Environmental Minor Project Refinement Form

Project Name: West of Devers Upgrade Project **Request Prepared By:** Sylvia Granados

Date Approval Required: 3/15/2021 **Variance Request No.:** 45

Southern California Edison
West of Devers Upgrade Project
Proposed Work Areas
MPR #45

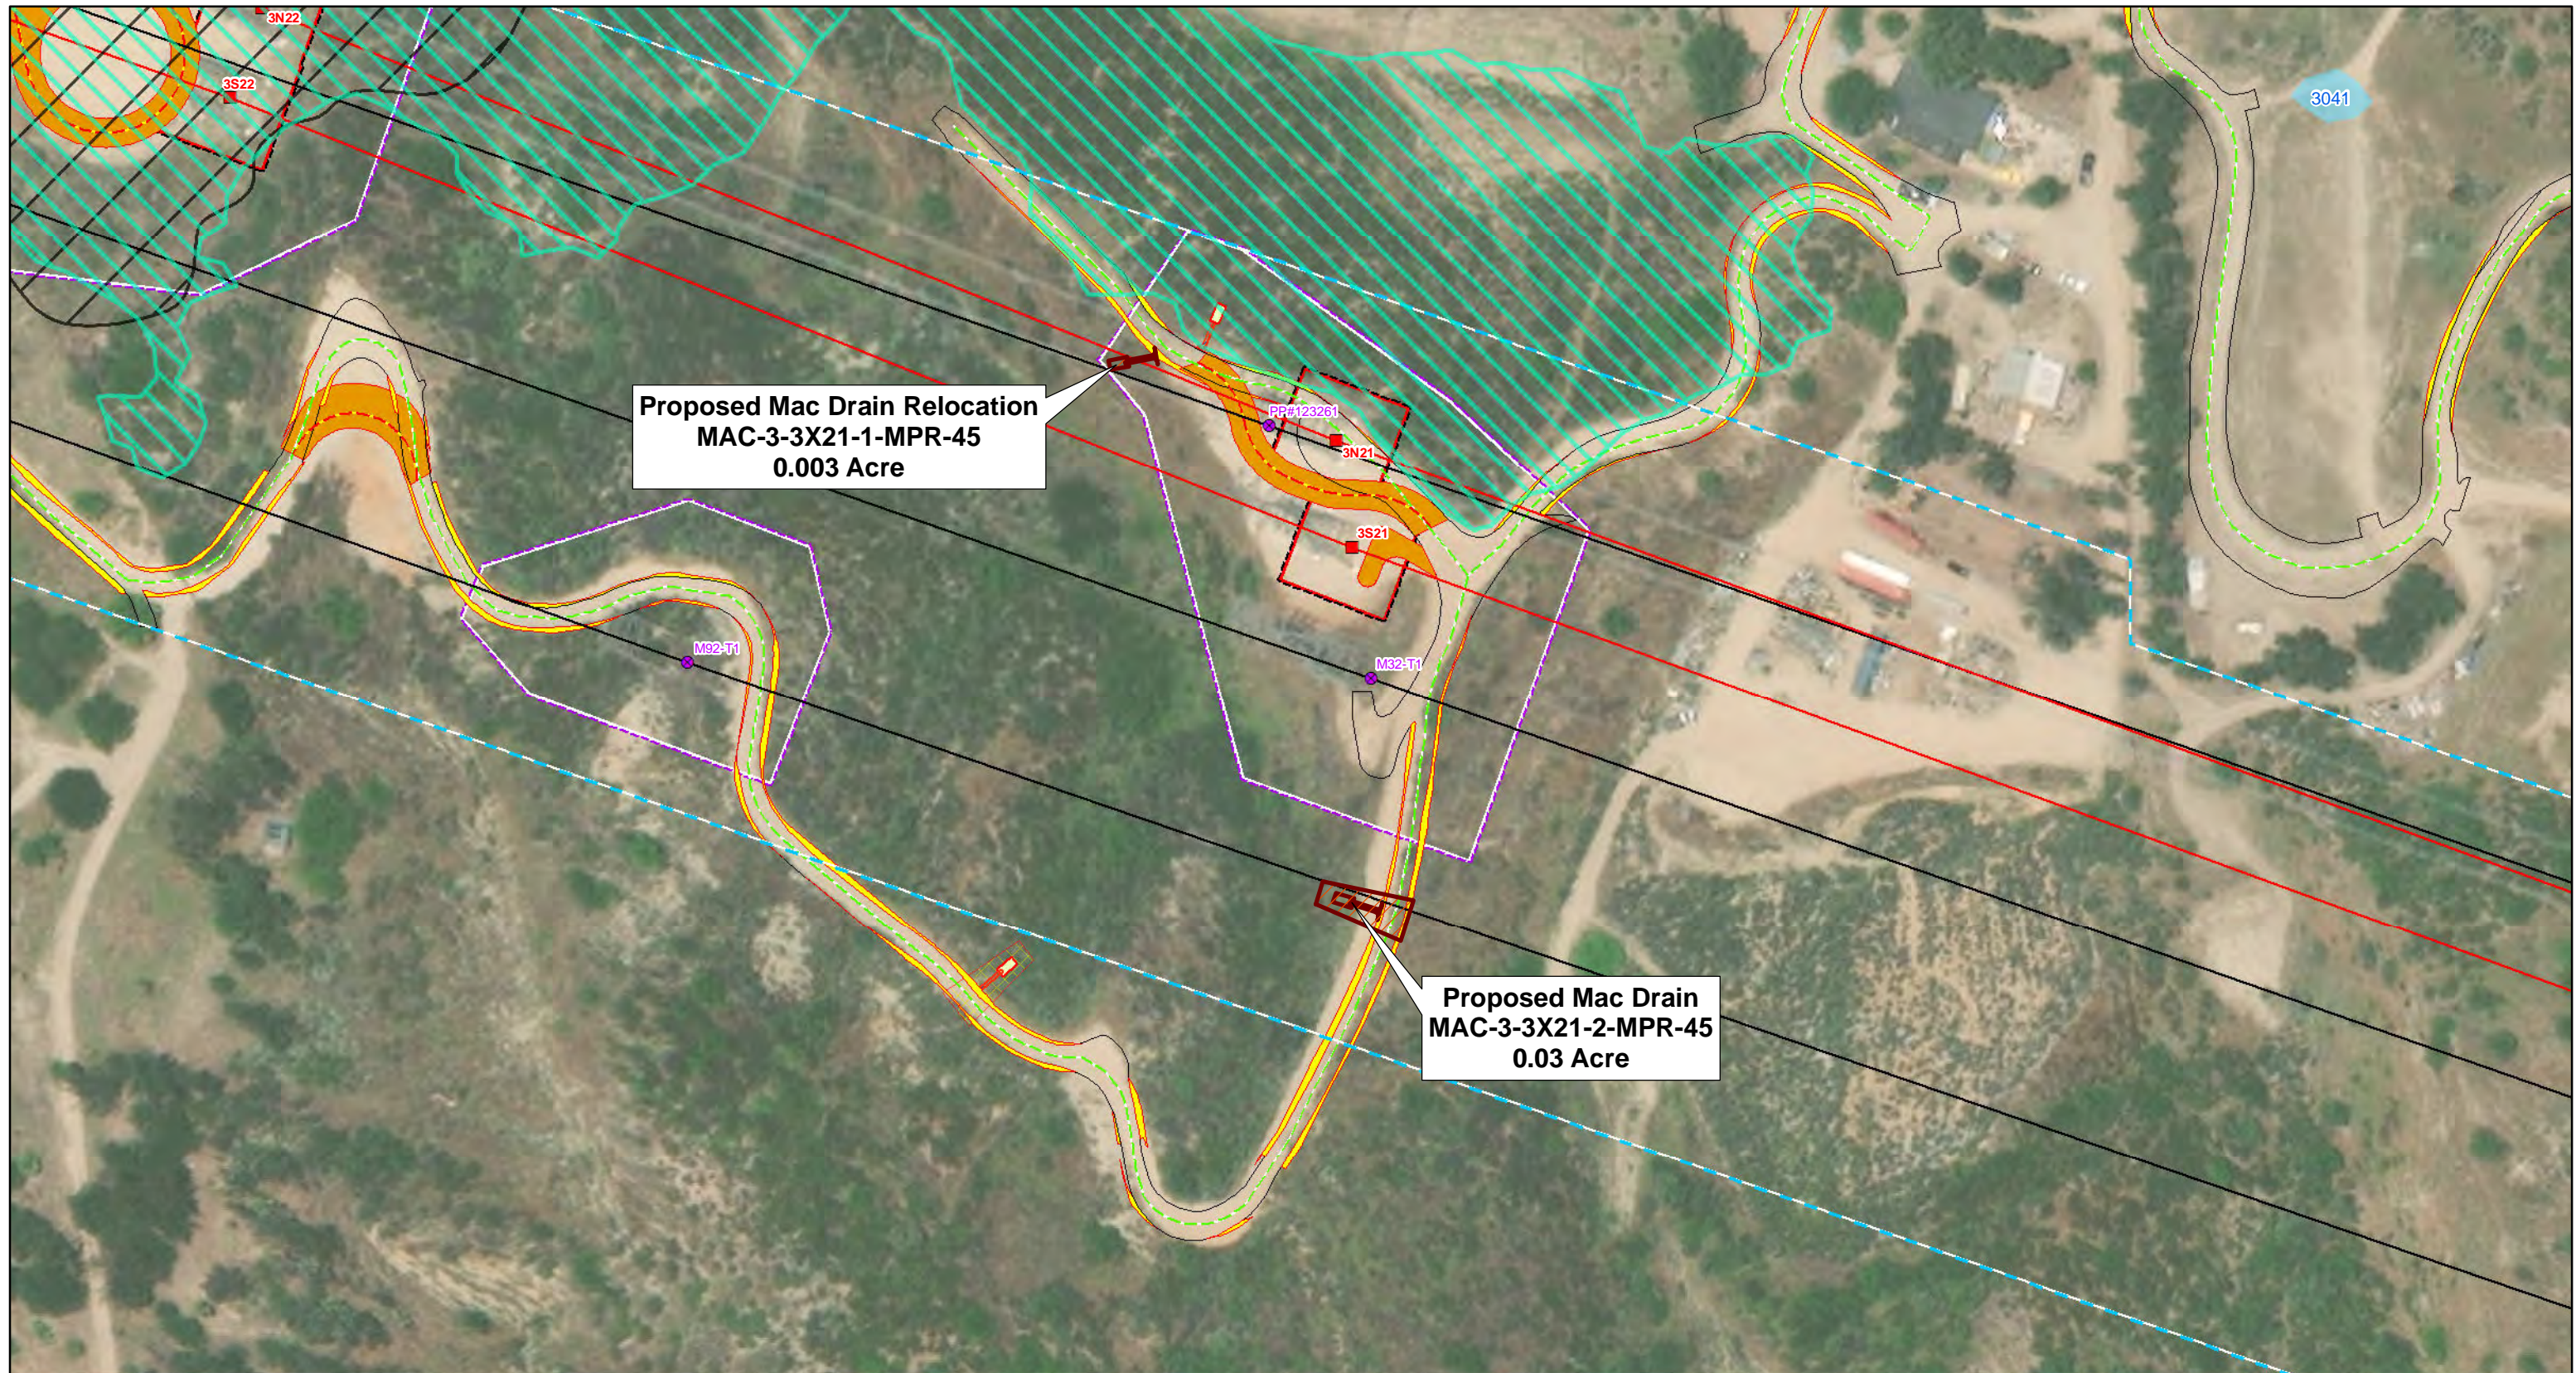
MWL-3-S-3X64-1-MPR-45 - Figure 1, page 1: Proposed McCarthy Drain Relocation

The originally planned location of MWL-3-S-3X64 has been redesigned to shift the installation approximately 50-feet southeast to better capture and divert stormwater flows off the utility access road into upland areas north of the roadside. No new impacts will occur as a result of the design shift because the removal of the McCarthy drain design from the original location will offset the impacts in the redesigned location, as shown on Figure 1, Page 1.

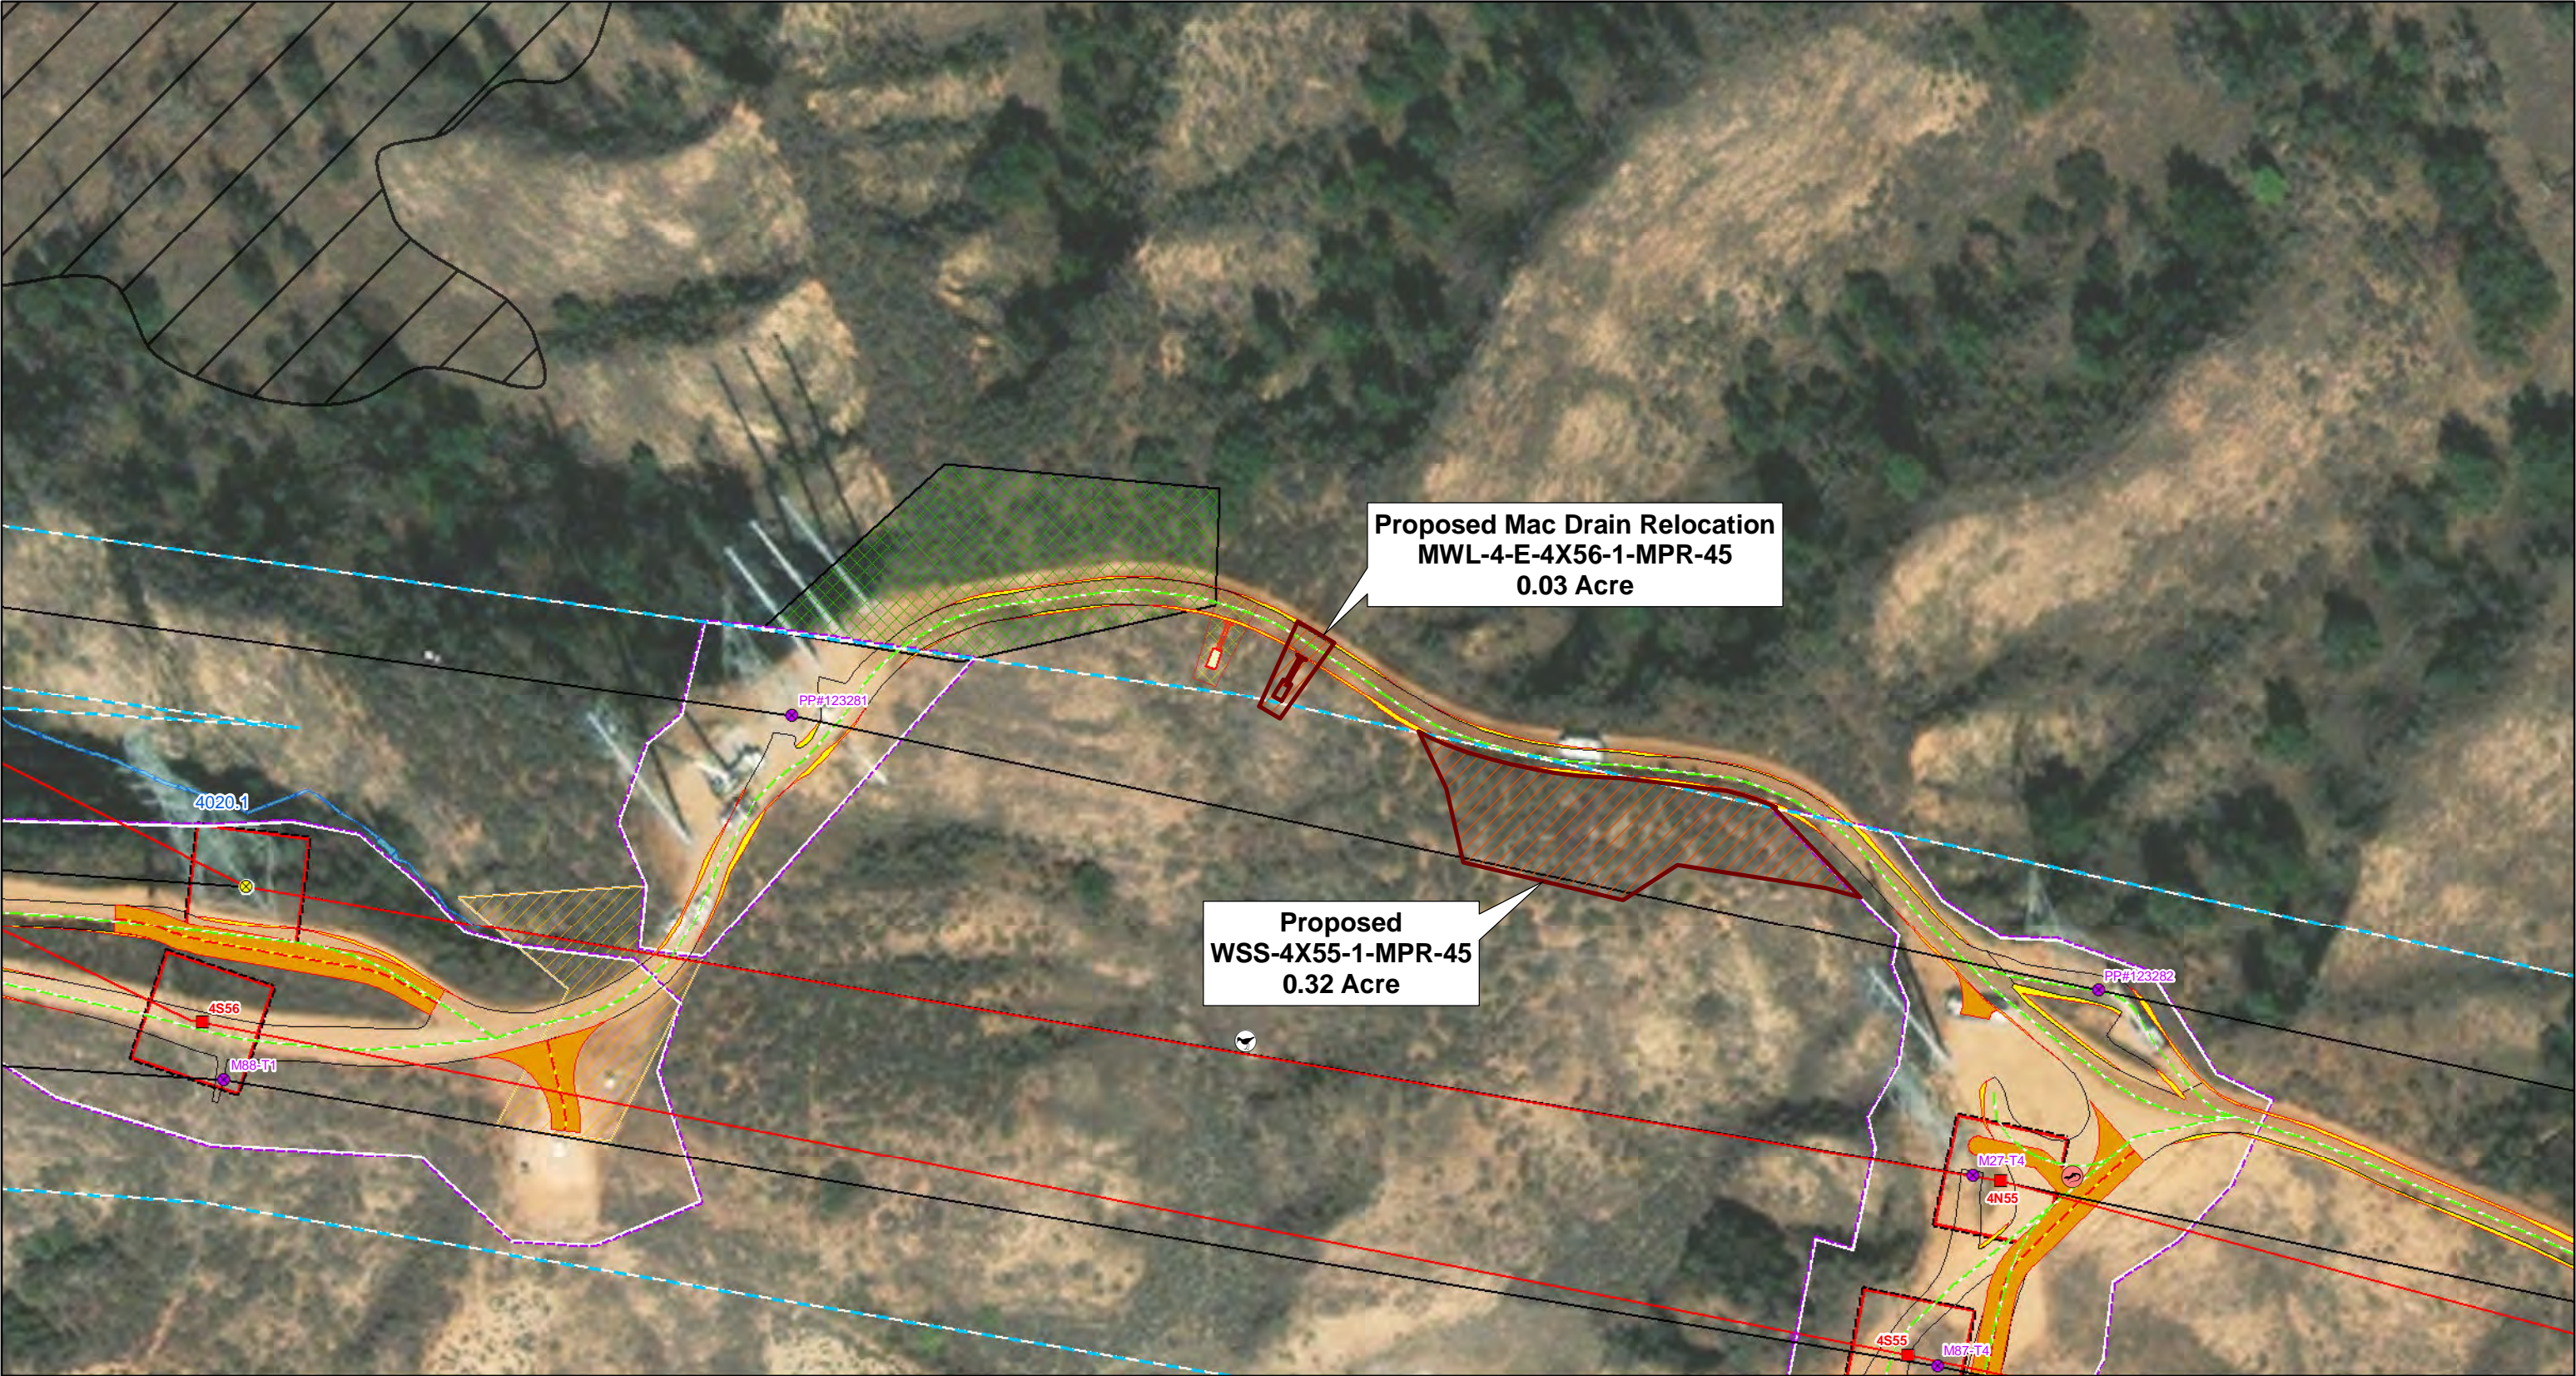
MWL-3-3X21-1-MPR-45 - Figure 1, page 2: Proposed McCarthy Drain Relocation/Installation

The originally planned location of MAC-3-3X21 has been redesigned to shift the discharge point from the north side of the access road to the south side of the access road, to better capture and divert stormwater flows off the utility access road into upland areas south of the roadside. No new impacts will occur as a result of the design shift because the removal of the McCarthy drain design from the original location to MWL-3-3X21-1-MPR-45 will offset the impacts in the redesigned location, as shown on Figure 1, Page 2. In addition, a new McCarthy Drain will be installed at MWL-3-3X21-3-MPR-45 to capture and divert stormwater flows off the utility access road into upland areas west of the roadside.

FIGURE 1
Page 4 of 10

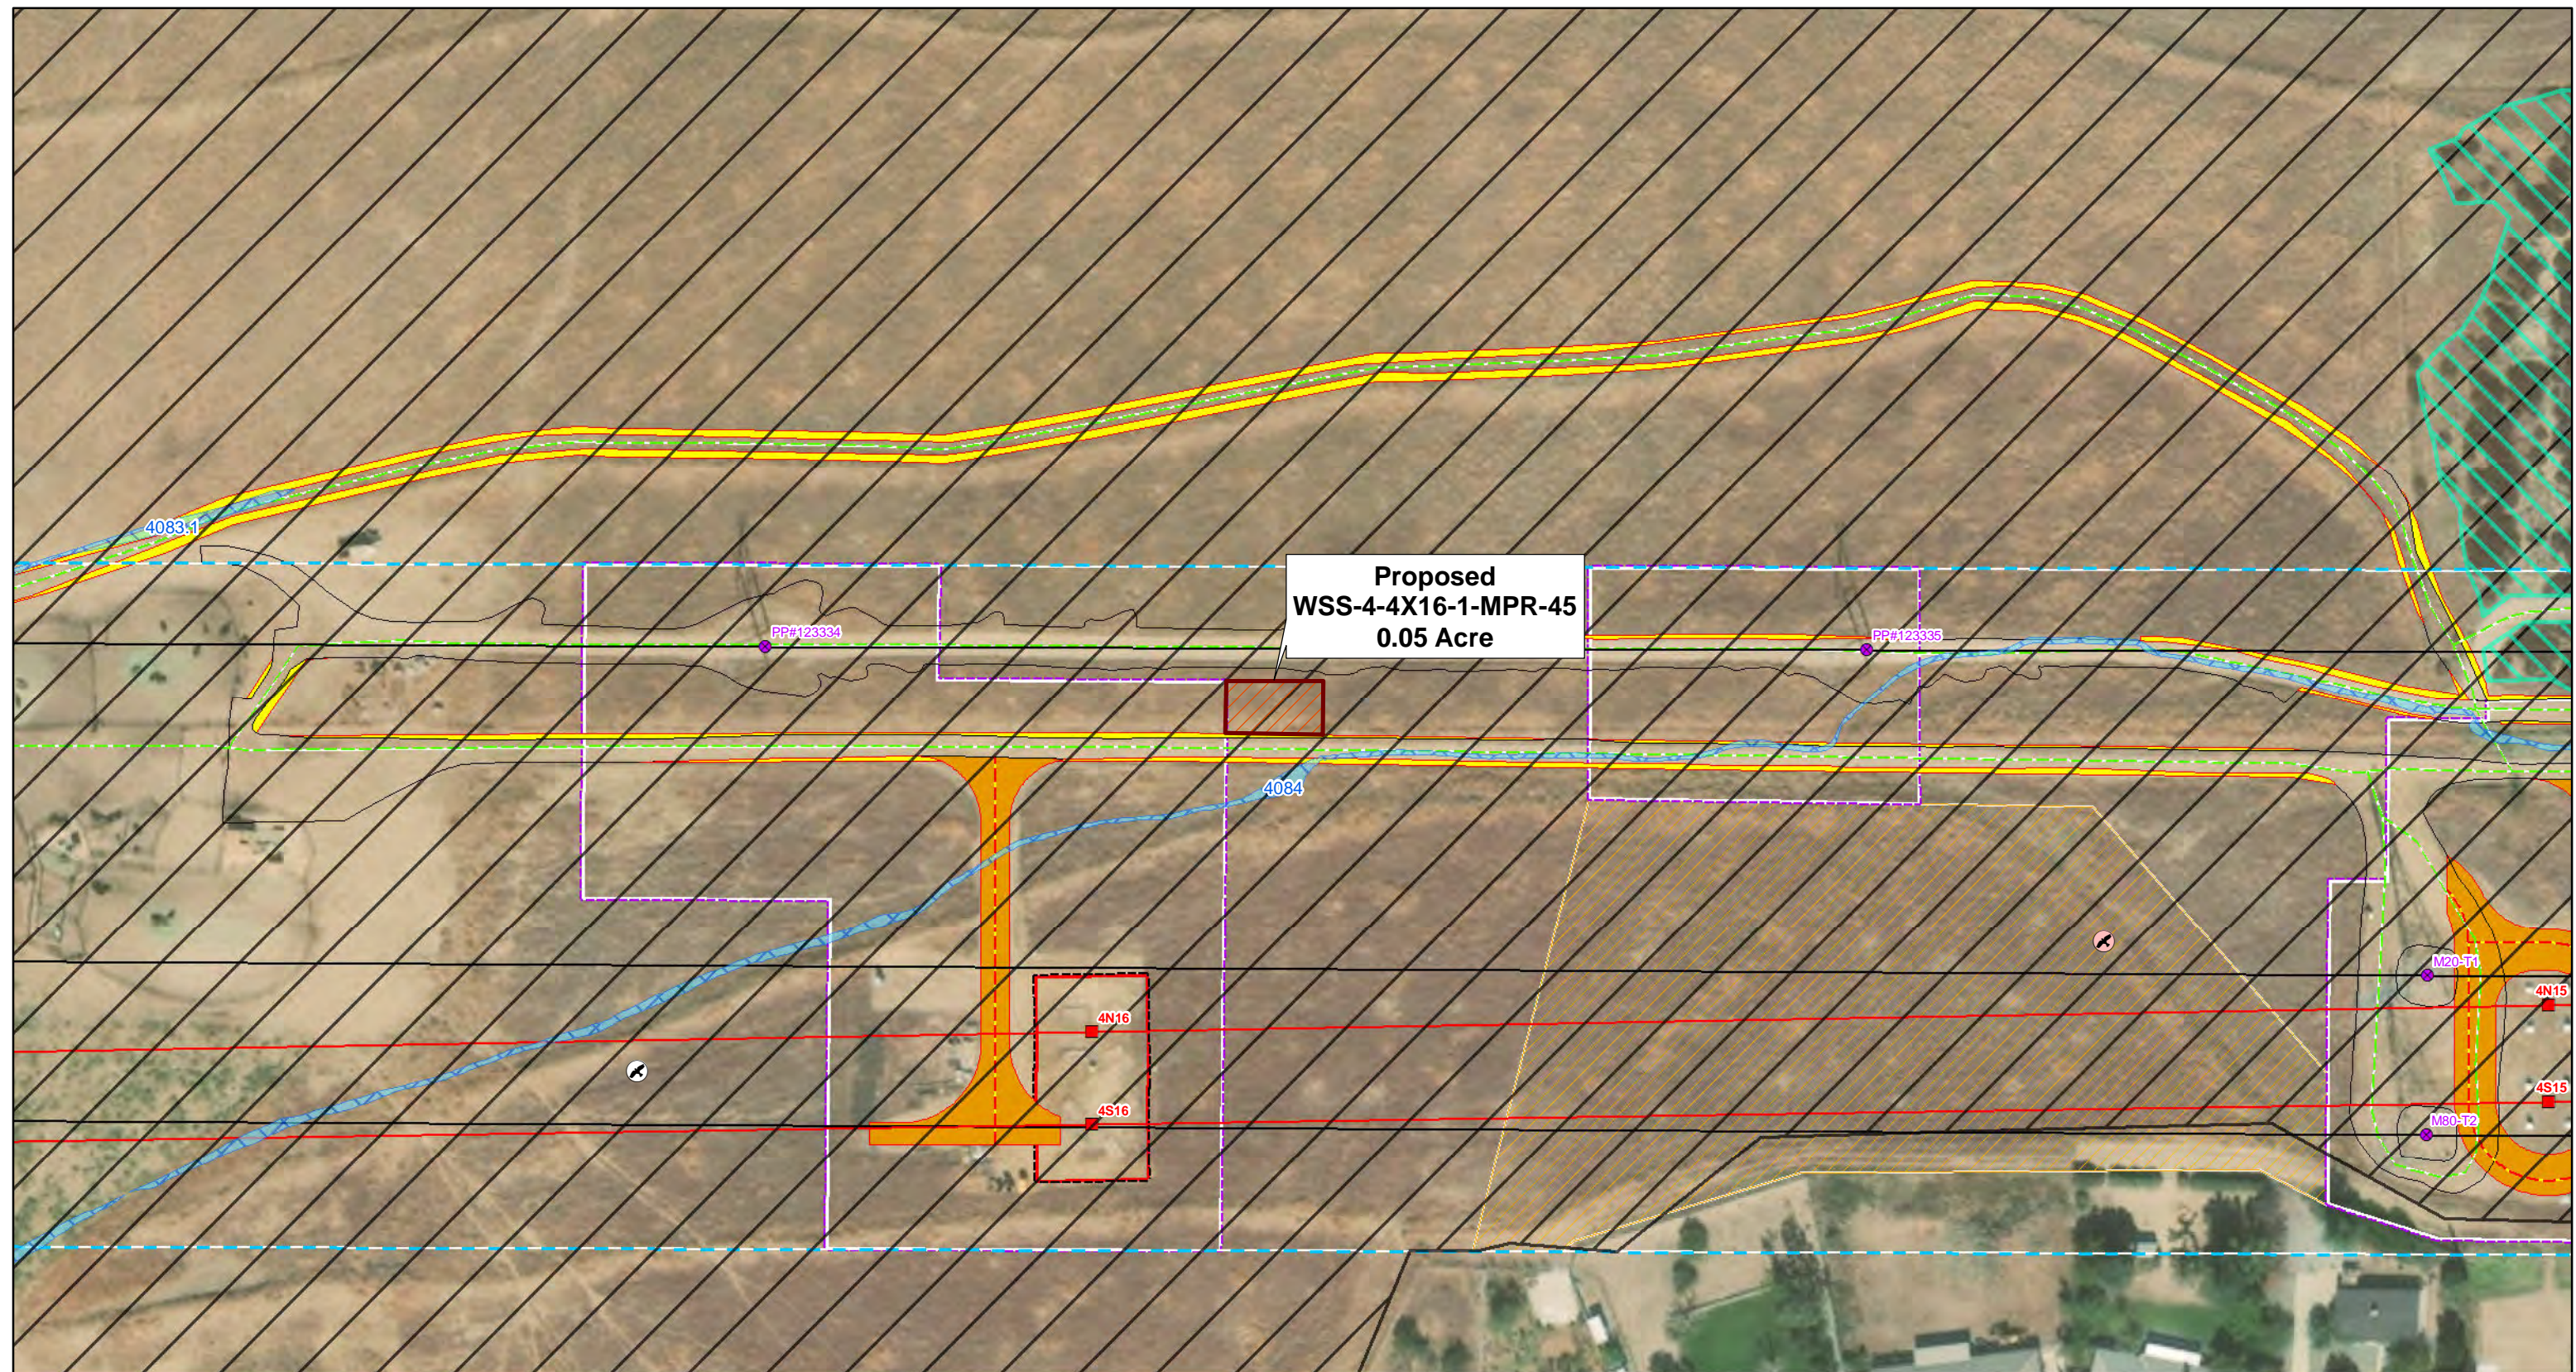
MWL-4-W-4X54-1-MPR-45 - Figure 1, page 4: Proposed McCarthy Drain

A new 0.01-acre work space is required to install a new McCarthy drain along the access road northeast of 4N54 to capture and divert stormwater flow off the utility access road and into upland areas north of the roadside, as shown on Figure 1, Page 4.

Special-status Plants – Plummer's mariposa lilies were observed in the vicinity of proposed MWL-4-W-4X54-1-MPR-45, as shown on Figure 1, page 4. However, no special-status plants were observed within the new work area itself, and due to the high levels of disturbance and compaction along the roadside, no impacts to these plant species are anticipated.
